## Comments on Carp River Third Party Review

Ted Cooper, M.A.Sc., P.Eng.

April 19, 2009

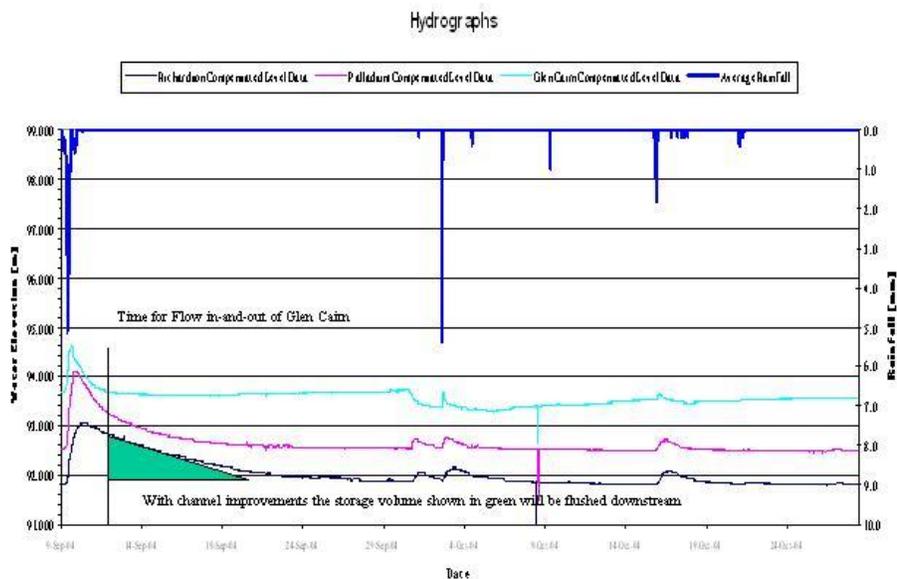
Because pump stations can be vulnerable during floods, the proposed implementation plan presents a problem for the designers of the Kanata West pump station. It will likely take five years to bring such a facility into service. There has to be certainty in the flood elevation from which the design of the facility is to be based. When such an investment is being made, there should not be any surprises when results finally trickle from the model calibration / adaptive management

process, only to find the station has been designed on the basis of the wrong flood elevation.
